Group submission relating to application SSD 5878

Sydney International Convention, Exhibition and Entertainment Centre Precinct
Mixed use Development in the Southern Haymarket Precinct (Concept Proposal) (SSD)

Summary

7428A	IMCJ AR D357	01/03/2013	DENTON CORKER MARSHALL	THE HAYMARKET LEND LEASE DEVELOPMENT	DEVELOPMENT APPLICATION PEAK TOWER - NORTH ELEVATION PROPOSED BUILDING PROFILE OVERLAY
-------	--------------	------------	------------------------------	---	--

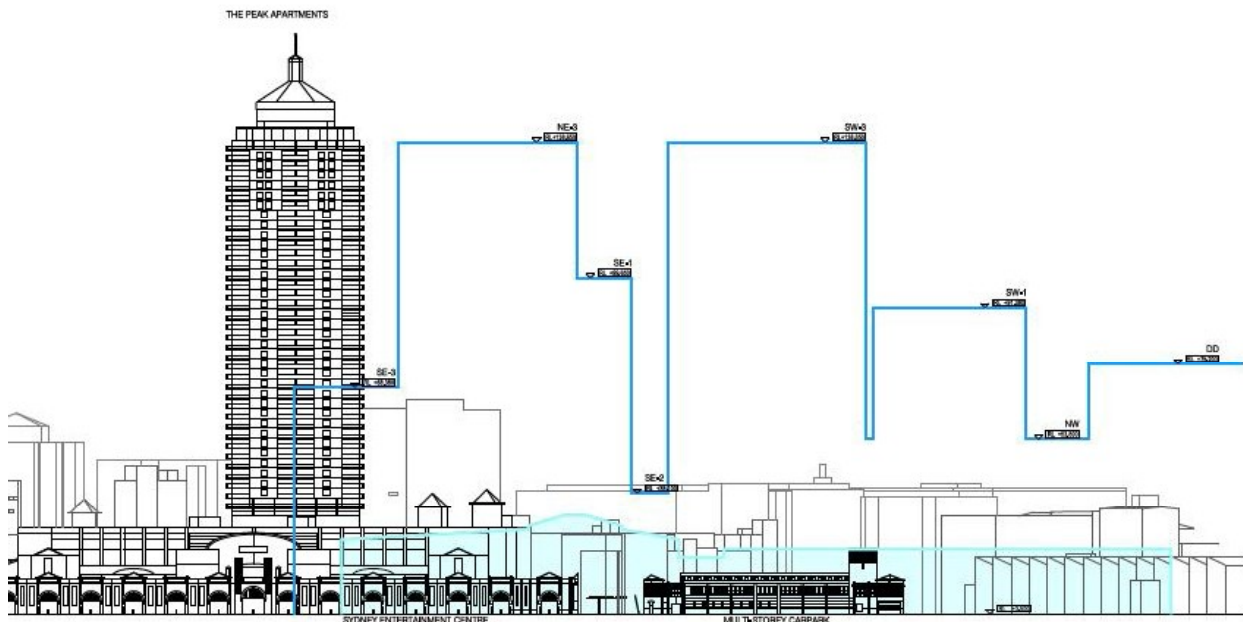
This shows these planning guidelines have been ignored in the drive for increased density and optimum placement of the new towers for maximum return - all with scant regard for the existing buildings.

The loss of amenities, outlook and views is an excessive burden on the residents of the Peak and for all the residents of surrounding buildings. At a minimum, it is imperative to delete the Tower SE1 from the planned development.

The following figure buried in SSD 5755 illustrates the size of the proposal in relation to The Peak.

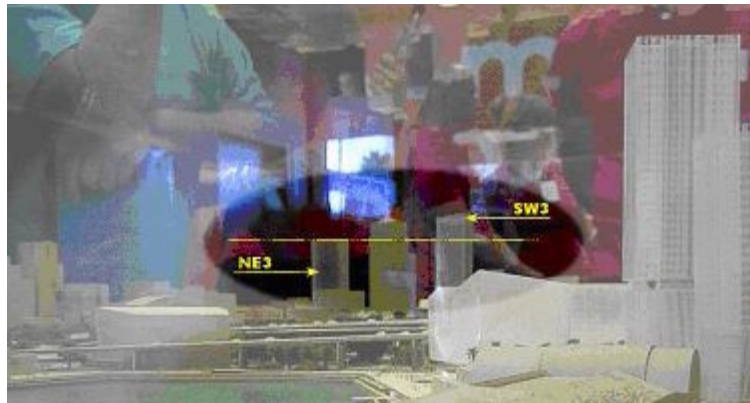
- *Views to the Powerhouse Museum will be affected by the two residential blocks in the Haymarket Precinct situated next to the Rail Corridor, which will also be impacted. Principal views to the Powerhouse Museum are available from Harris Street and will not be affected by the proposed development, while views to the building are of secondary importance.*

The student blocks and tower SW 1 will obscure the sight lines to the Museum from the southwest and the CBD. Why is it deemed sufficient to retain only the western façade when the eastern façade is the most important one.

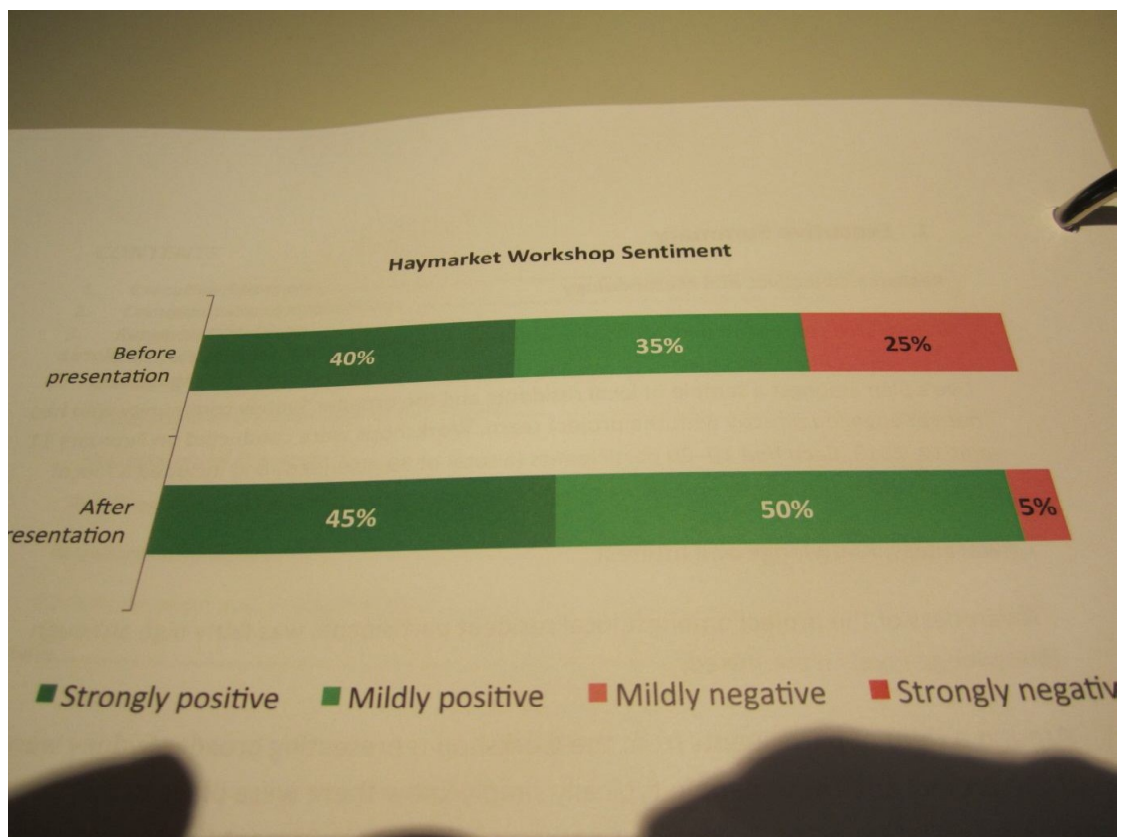
The information given during consultation was very much smoke and mirrors. The statements given on the height of the towers was vague and variable with the number of floors being defined from the podium level in some cases. The RLs of the top of the towers were not disclosed prior to the EIS being lodged. In fact tower NE3 grew about 8 floors after consultation. This is clear from photos of the original model.
